BECK NORTH UNIT 54 – LANDBANK PARKING JSP 16-36

Consideration at the request of Dembs Development for Revised Preliminary Site Plan with Land bank Parking approval. The subject property is located in Section 4, east of Beck Road and north of West Road on Nadlan Court, in the Light Industrial (I-1) zoning district. The applicant previously received Special Land Use and Preliminary Site Plan approval for a 67,000 square foot speculative building in October 2017. The applicant now proposes to add a mezzanine (21,348 sf) to the building for additional office space for a tenant identified to occupy the building, as well as 32 land bank parking spaces and other minor changes to the site. The proposed parcel is approximately 5.53 acres.

PLANNING REVIEW

Review Date: April 11, 2019
Review Type: Revised revised Final Site Plan
Project Name: JSP 16-36 BECK NORTH UNIT 54
Plan Date: 3-19-2019
Prepared by: Lindsay Bell, Planner
E-mail: lbell@cityofnovi.org; **Phone:** 248.347.0484

PRELIMINARY SITE PLAN
 BECK NORTH CORPORATE PARK - UNIT 54
 SECTION: 4

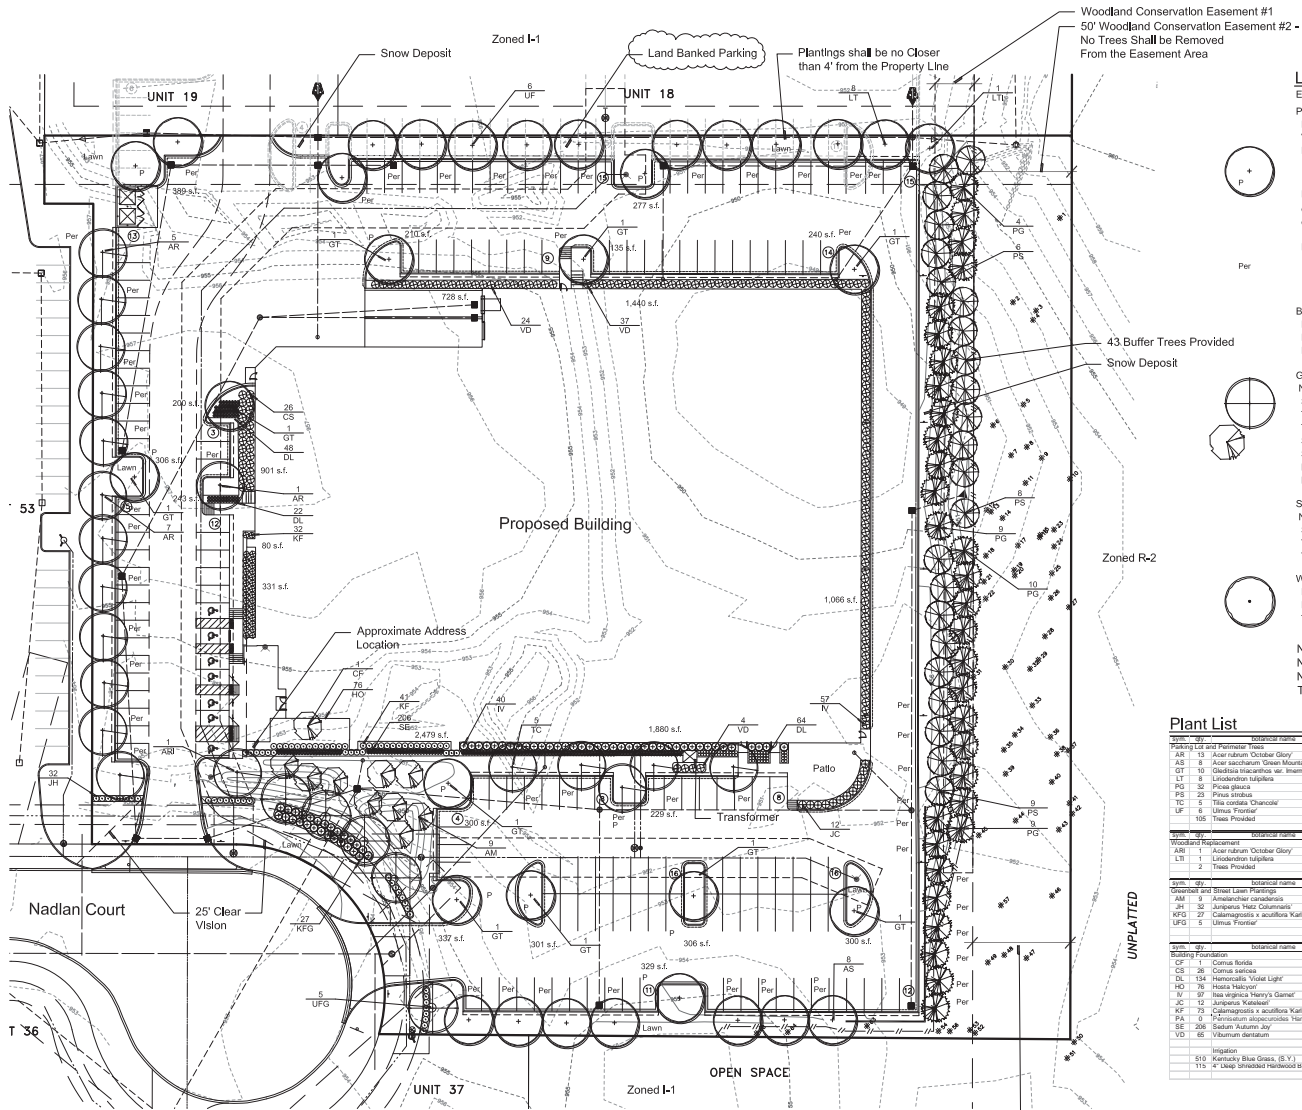
1. Landbank Parking (Sec. 5.2.14): The applicant is requesting Planning Commission approval of 32 landbank parking spaces. **The applicant shall include a written justification to demonstrate the actual requirements for the functional use of the building for the occupant identified.** This could include employee counts and other supporting information.

Please add a clearly visible note in a box to Sheet L-1 with this text:

43 BUFFER TREES ARE PLANTED ALONG THE EAST SIDE OF THE SITE THAT COUNT TOWARD THE TOTAL NUMBER OF TREES REQUIRED UNDER IN THE CONSERVATION EASEMENT DATED APRIL 5, 2010 (LIBER 42076 PAGE 272).

1. Based on the vehicular use areas, 2,625 sf of landscape island area and 13 deciduous canopy trees are required. Per the plan, approximately 4,482 sf of islands and 12 trees are provided (not all of the areas are labeled).
2. The central island on the north side of the building is only 135sf in area, partly due to the increased bike rack. **While this is non-conforming, it will be accepted as is but it is recommended that the honeylocust be replaced with a smaller tree, such as *Carpinus caroliniana* (not *Carpinus betula*), but still has a minimum mature canopy width of 20'.**
3. **The patio endcap must have a deciduous canopy tree. The Keteleer junipers will provide some separation for the users of the patio, but will not provide the shading that a**

deciduous canopy tree would provide. Please restore 200sf of greenspace and a canopy tree to that area.

Please provide a landscape plan for the land-banked parking area that meets all current landscape ordinance requirements. Calculations and a separate plant list for the area should be provided on that plan.

- The applicant has provided a written justification to demonstrate the actual requirements for the functional use of the building for the occupant.
- Parking notes ii-v. on page 4 of the review will be added to the site plan as well as “The owner of the property shall report any proposed change in use or occupancy of the property to the Building Official prior to said change, who shall evaluate the need for some or all of the landbanked parking spaces to be installed.”
- The tenant/occupant will provide an updated Hazardous Materials Checklist and Emergency Contact form for the Fire Department’s records with the next submittal.
- No changes to the lighting levels/plan are proposed.
- Property line adjustments and amended Master Deed will be provided prior to Stamping Set approval.

- A note will be added to sheet L-1 regarding the 43 buffer trees counting towards the required trees under the conservation easement.
- The honey locust in the center island on the north side of the building will be substituted with a smaller tree.
- The patio endcap will have a 200 s.f. landscape island and tree.
- A separate landbank plan with calculations will be provided.

EAST ELEVATION
 SCALE: 1/16" = 1'-0"

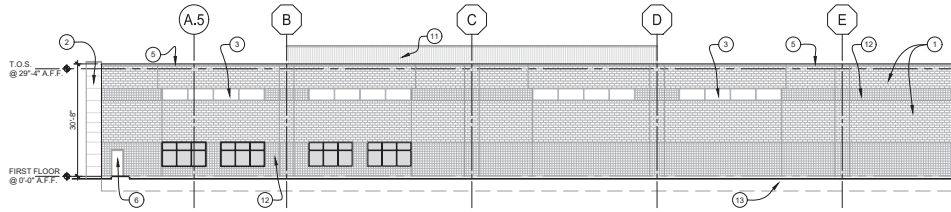
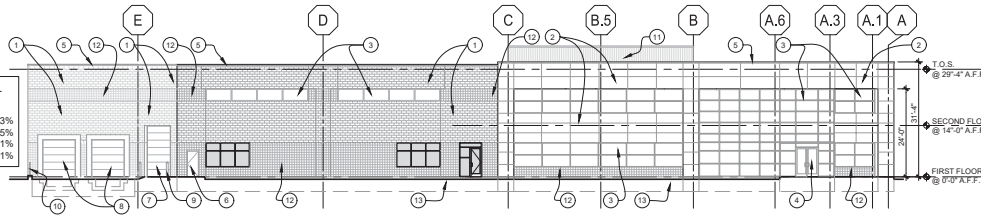
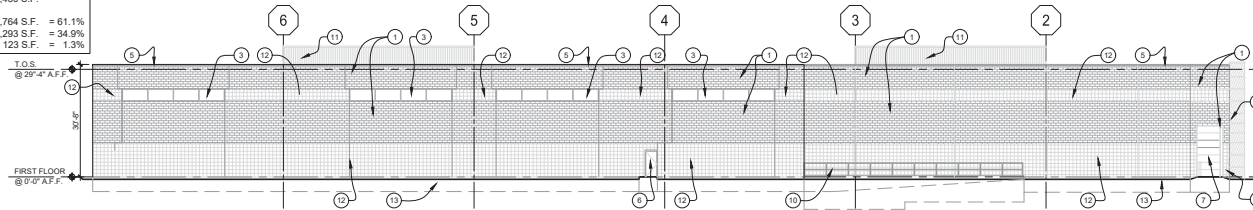
As shown above the combined percentage of Concrete Masonry Units (C.M.U) exceeds the maximum amount allowed by the Ordinance on the east and north façades. A Section 9 Waiver was granted by the Planning Commission for this deviation during their 10/11/17 meeting.
